FRONT MOUNT HELM PUMPS

Teleflex Marine would like inform you of an upcoming and exciting change to the SeaStar and SeaStar PRO helm pumps.

Figure A. New look Vent Plug, Part # HA5431,
New look NON-Vent Plug, Part # HA5432.

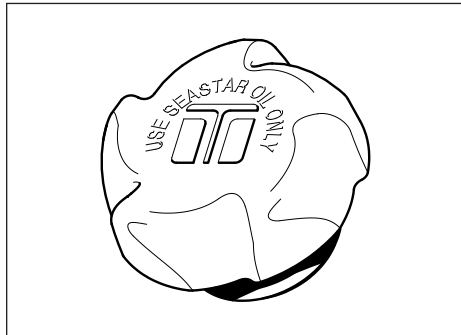
- New style enhances the new front cover style change.
- Ergonomic design to assist with the installation and removal of the vent and non-vent plug, resulting in less chance of over-tightening leading to damage.

- NO change to installation.
- NO change to operation and/or performance.
- Will be shipped with ALL SeaStar and SeaStar PRO helm pumps.

Figure B. New look SeaStar/SeaStar PRO Helm Pump.

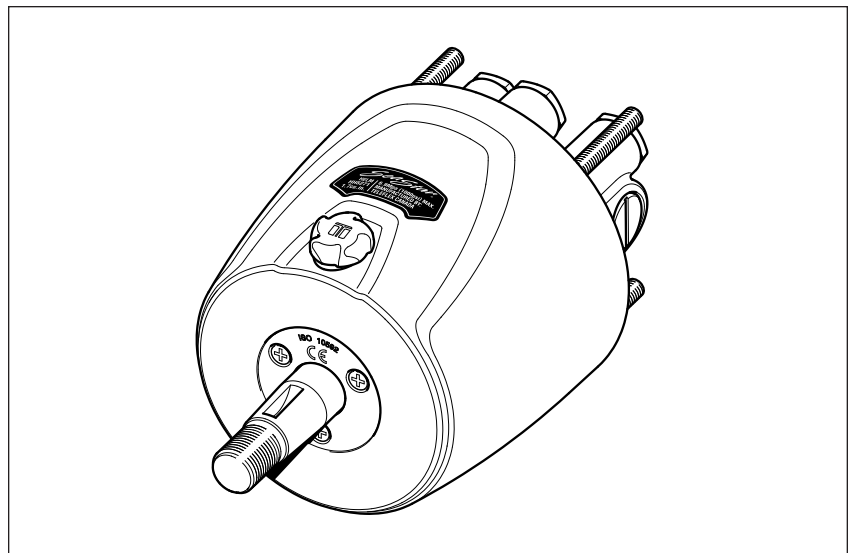
- Enhance the appearance of your dash.

- ALL SeaStar and SeaStar PRO helm pumps (excluding traditional/classic tilt helms).

- NO change to installation.
- NO dimensional changes.
- NO change to operation and/or performance.
- CAN be used with older model SeaStar helms in multi-station setups.

- Patent pending air chambers added within the helm, reducing the risk of leaks due to temperature fluctuations.
